MIL-B-48024 (AR)
AMENDMENT 3
11 May 1988
SUPERSEDING
AMENDMENT 2
9 DECEMBER 1987

MILITARY SPECIFICATION

BOXES, AMMUNITION PACKING: WOOD,
(W/PLYWOOD TOP AND BOTTOM) NAILED

This amendment forms a part of Military Specification MIL-B-48024 (AR), dated 3 February 1972, and is approved for use within the U.S. Army Armament Munitions and Chemical Command, and is available for use by all Departments and Agencies of the Department of Defense.

FIGURE 5. Type II, Class 2 Box.

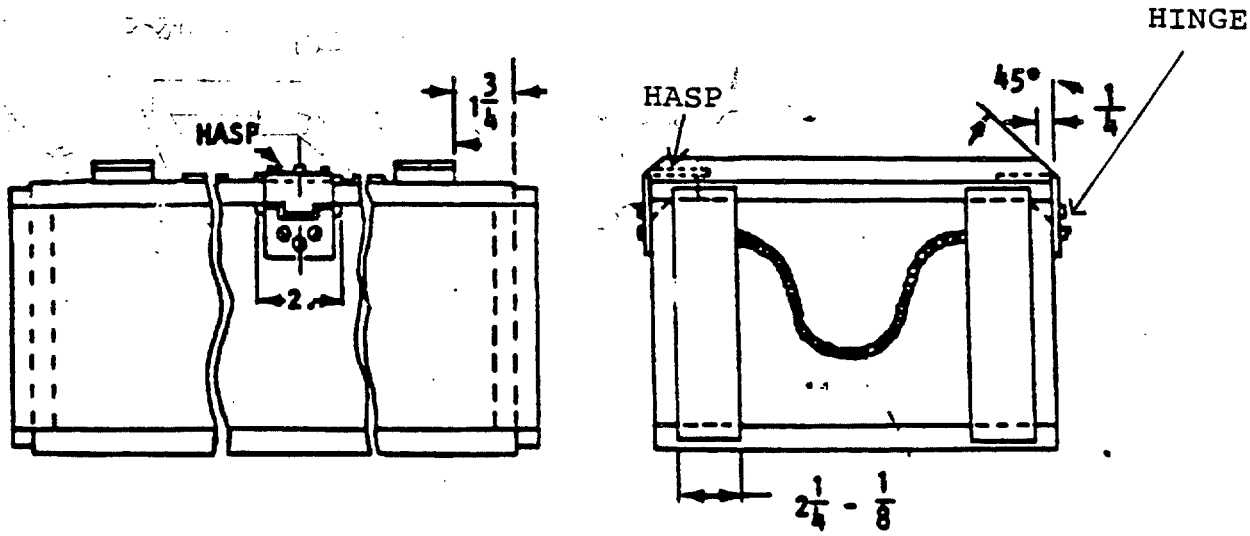
After "9266797 - Hasp", add "(except Figure 5)"
After "9266798 - Hinge, Pinless (Tang and Receiver)", add "(except Figure 5)"
After "MS51862 - Screw, Tapping . . . . . MS51862-24", add "(except Figure 5)"
Add "8796523 - Hasp (Figure 5)"
Add "8796524 - Hinge (Figure 5)"
Delete "Any box for which hardware is specified, shall have one hasp and one pinless hinge regardless of box length" and substitute "Any box for which hardware is specified, shall have one hasp and one pinless hinge regardless of box length. NOTE: Figure 5 will use hinge 8796524 in place of the pinless hinge."

Figure 5. Delete in its entirety and substitute the attached Figure 5.
